U. S. NUCLEAR REGULATORY COMMISSION

Report Nos. 50-272/87-07 05000272-870312
50-311/87-08 05000311-870312

Facility Name: Salem Nuclear Generating Station - Units 1 and 2

Inspection Summary:

NOT TO SCALE
VIEWED FROM UNDER THE PIPE

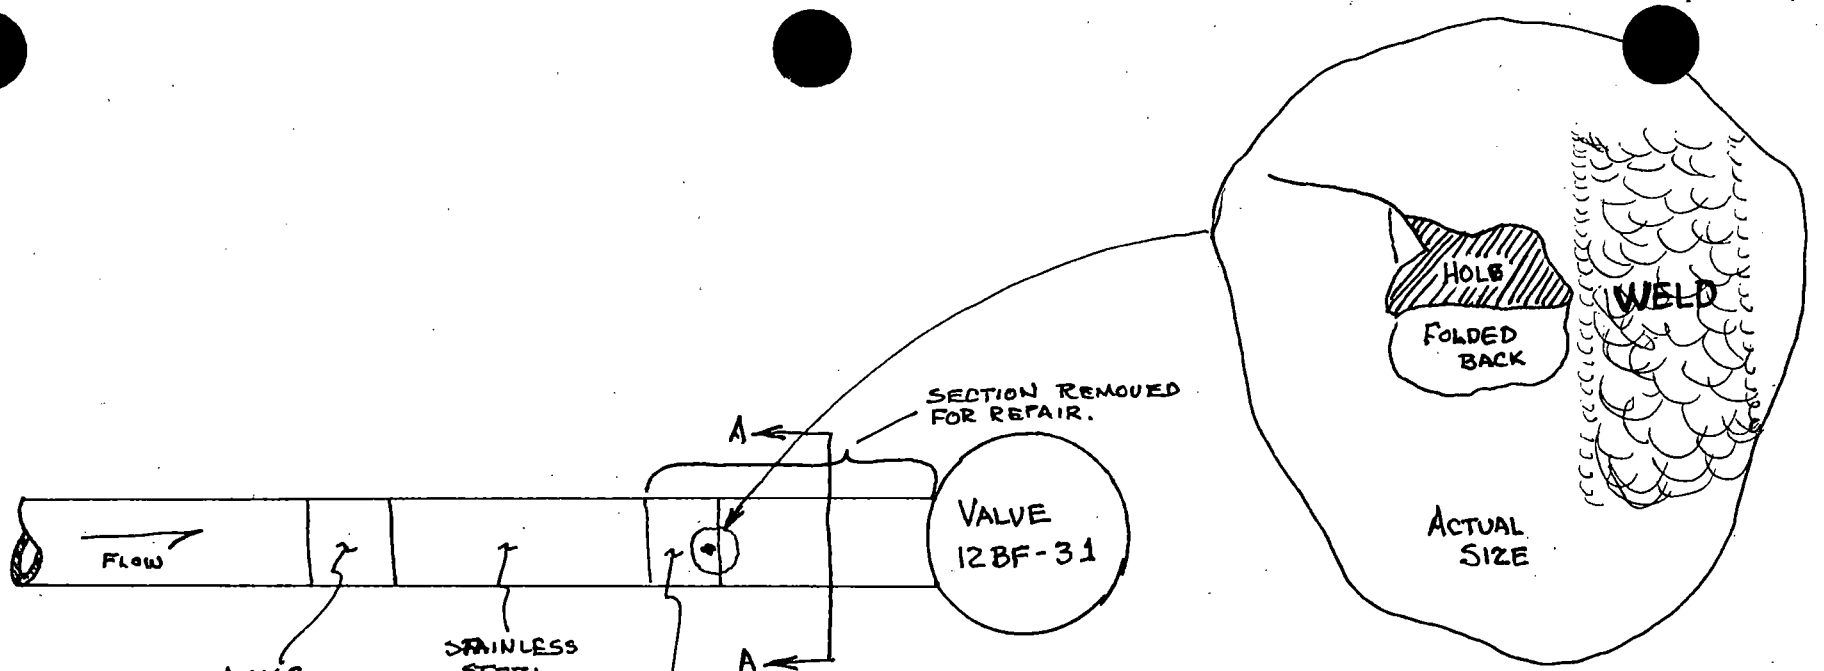
During Unit 1 startup on March 16, 1987 at approximately 1:00 p.m., the licensee identified a leak on No. 12 steam generator feedpump (SGFP) recirculation line to the condenser. The leak resulted from a 1/2 inch by 1 inch hole in the piping near a carbon to carbon weld located between a stainless steel flow restricting orifice and valve 12BF31 (see Attachment 3 to this report). The piping is 6 inch A106 Grade B carbon steel with 0.432 inch nominal wall thickness. The break in the pipe occurred where erosion had thinned the pipe near the weld backing ring which protruded into the pipe. Although thinning in the recirculation piping had been identified previously by the licensee (discussed in Inspection Report 50-272/86-32; 50-311/86-36), the section between the carbon to carbon weld and carbon to stainless weld had not been inspected.

1. Cut out the section of pipe, as shown on attachment 3, for analysis to determine metallurgical root cause of the failure. The metallurgical laboratory's preliminary assessment of the cause was water impingement erosion as evidenced by flow disturbances indicated by swirl patterns observed through an etching technique.

4. Qualified a welding procedure for A106 carbon to 410 stainless steel.
5. Welded in new A106 piping as shown on attachment 3. The inspector noted that the backing ring technique was not used because the licensee believed that the backing ring of the previous weld protruding into the piping may have contributed to the thinning.
